SERVICE BULLETIN

TITLE : AIR CONDITIONING - PACK TEMPERATURE CONTROL - INTRODUCE IMPROVED PACK
TEMPERATURE CONTROLLER A-11

MODIFICATION No. : 27469K5430

SERVICE BULLETIN No. : A320-21-1111

Figure 1 Sheet 1

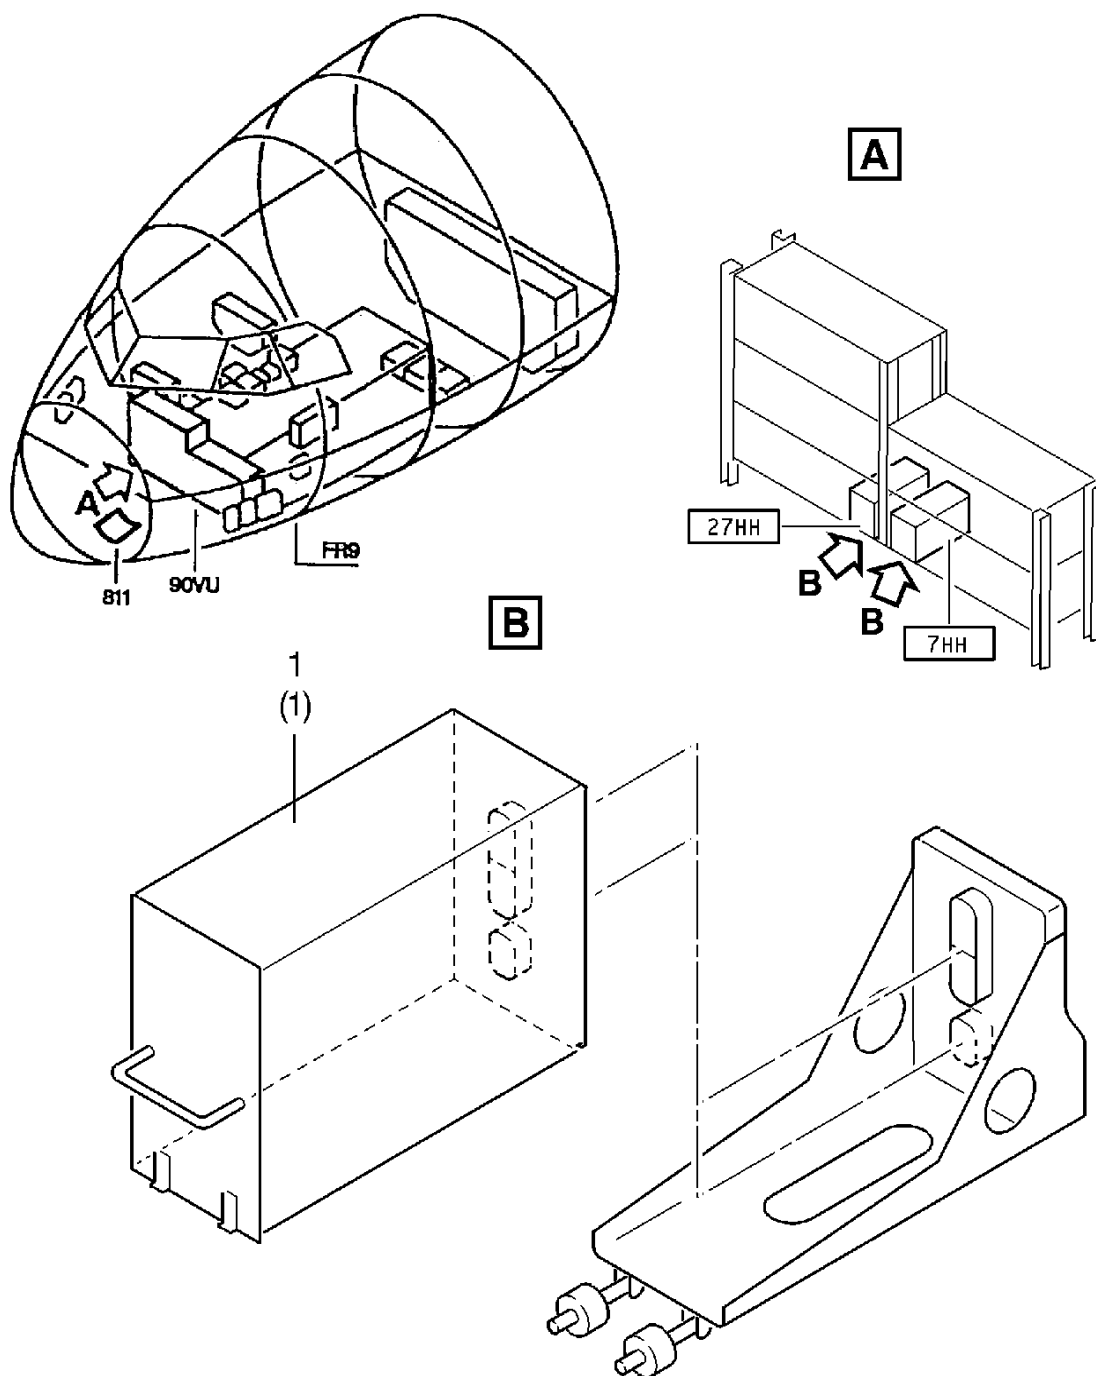
- (1) Remove the pack controllers 7HH and 27HH 759A0000-10, item (1), (Refer to AMM: 21-61-34, P. Block 401) as shown in the Figure.
- (2) Modify the pack controllers, item (1), (Refer to LIEBHERR-AEROSPACE LINDENBERG GmbH Service Bulletin 759A-21-07) on bench or send them to LIEBHERR-AEROSPACE LINDENBERG GmbH.
- (3) Install the pack controllers 7HH and 27HH 759A0000-11, item 1, (Refer to AMM: 21-61-34, P. Block 401) as shown in the Figure.
